PLANNING & ZONING CASE NO. MIS 2020-001

2930 Ridge Road [REVISED PLANS]

SUBJECT: MIS2020-001; Alternative Tree Mitigation Settlement Agreement

SIGN DETAIL

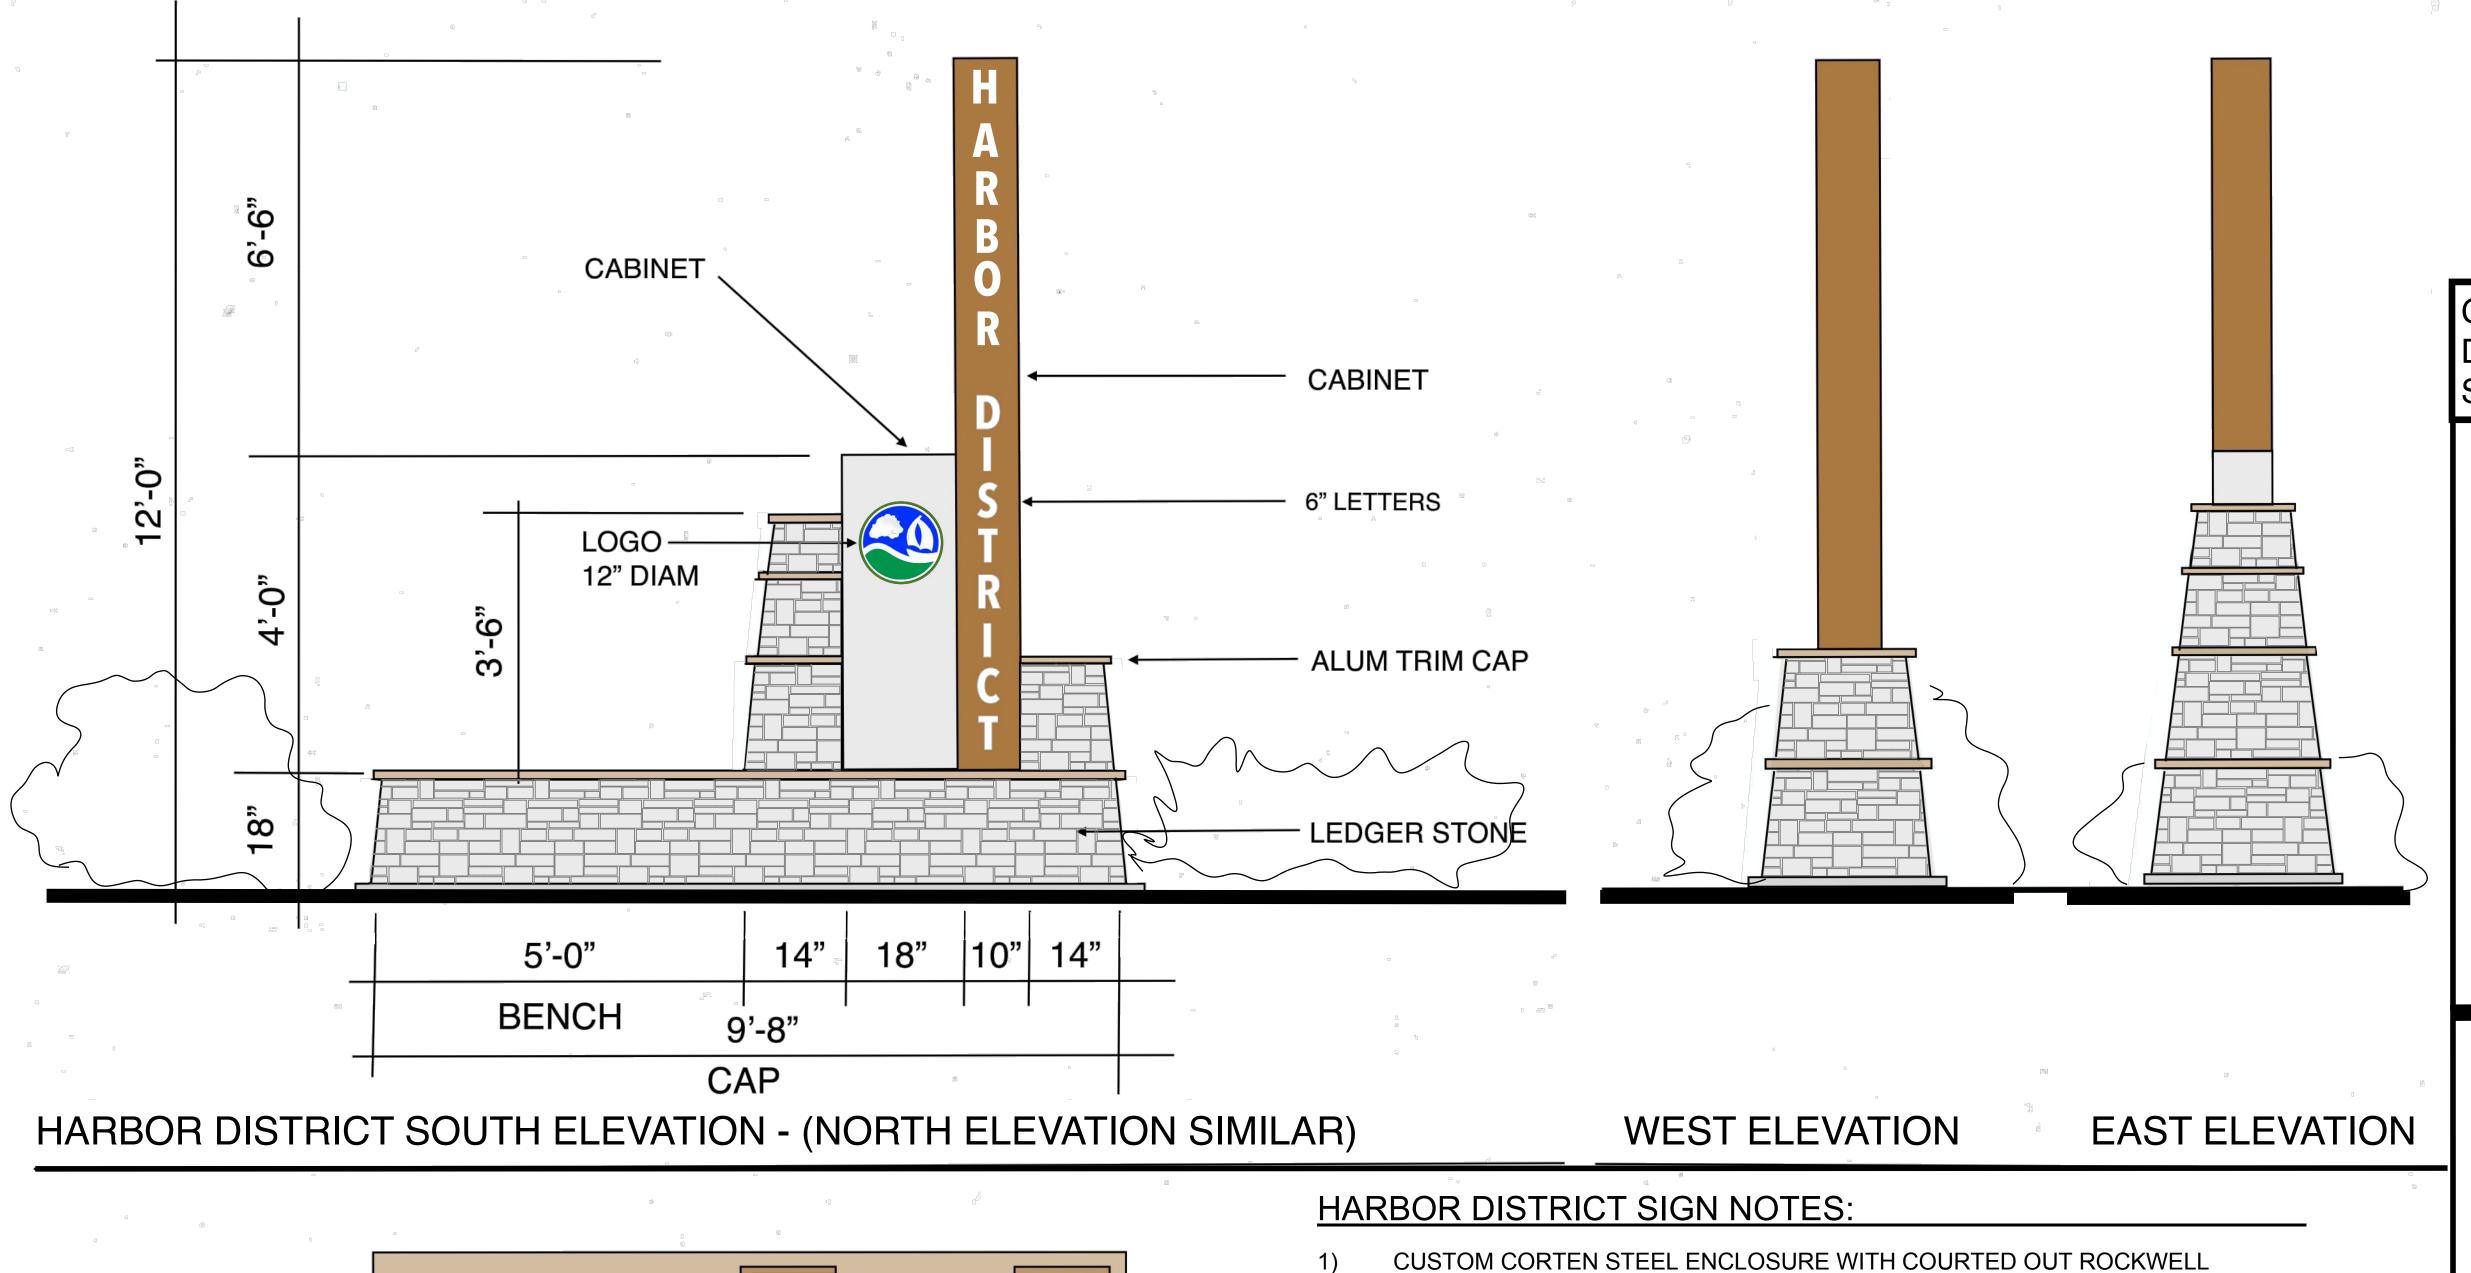
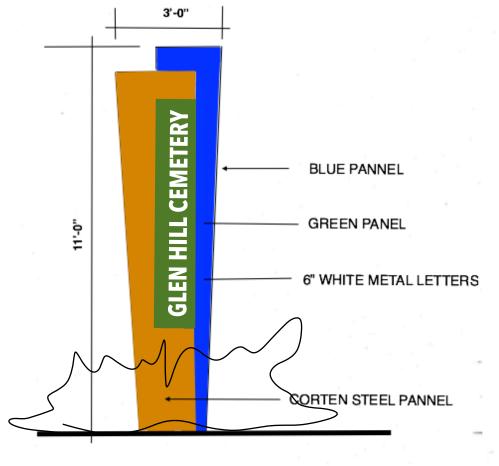
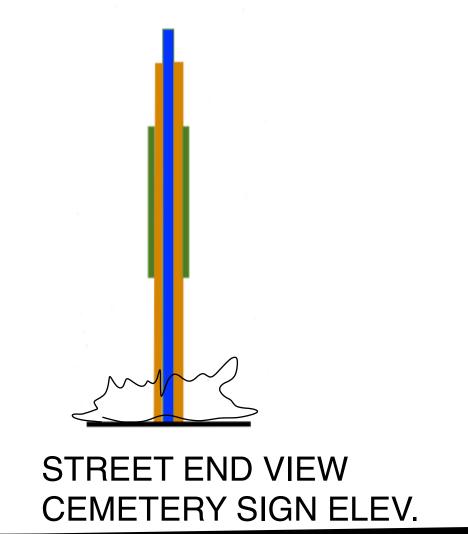
On February 11, 2020, the Planning and Zoning Commission made a motion to recommend approval of the alternative tree mitigation settlement agreement as requested with staff conditions and Architectural Review Board (ARB) recommendations. The ARB recommended the seat wall portion of the sign be removed (i.e. 18" portion). The motion passed by a vote of 7-0.
